PROJECT REVIEW COMMITTEE - CITY OF WILDWOOD
PRC Chairperson – Melanie Strickland

Agenda
Regular Meeting
February 10, 2026 10:00 AM
Commission Conference Room 124
100 N Main Street

- 1. SP 2410-004 Exalt Health Rehab Hospital Offsite Force Main Extension**

**PROJECT REVIEW COMMITTEE OF THE CITY OF WILDWOOD
EXECUTIVE SUMMARY**

(FOR CONTINUATION, SEE SHEET 04.06)

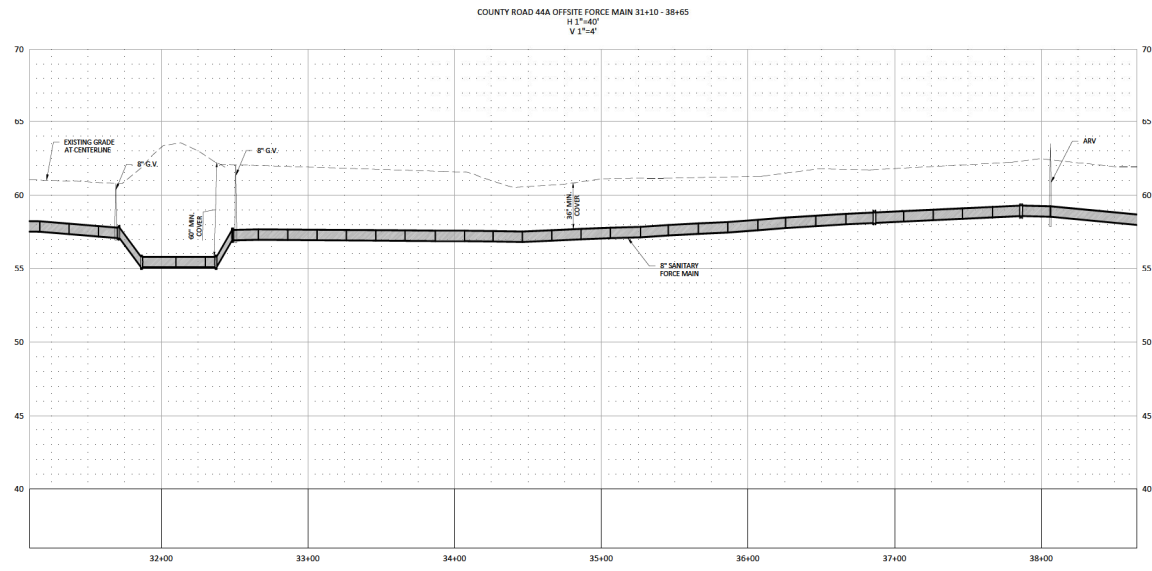
2. Sheet 04.06 – No right of way or easements shown for portion of the proposed line. Please mark any easements that may apply. Further discussion may be necessary.

- A. Response: That area is within the RxR R/W and will be handled with the RxR permitting.
 - I. There remain areas that are outside the railroad right of way that are not shown to have right of way. Sheet 4.07, not sheet 4.06 shows the railroad line. There is no “existing right of way” shown for the majority of Fifth Avenue on that sheet. Additionally, there may be other areas without shown right of way. The City cannot clear the installation of lines without appropriate right of way and/or easements. Accordingly, please review comments nos. 6, 9, and 10 again.

- a. Response: Please see the revised plans.
 - i. Not Satisfied.
 - a) Response: The R/W for CR 44A and the RxR has been shown and labeled. Most of Fifth Avenue on Sheet 04.06 is in the RxR R/W. There is not a separate road R/W within the RxR R/W. The plan shows where the Fifth Avenue R/W to the south connects to the RXR R/W. There is an utility easement shown on sheet 4.07 along the southern portion of the school board property.**
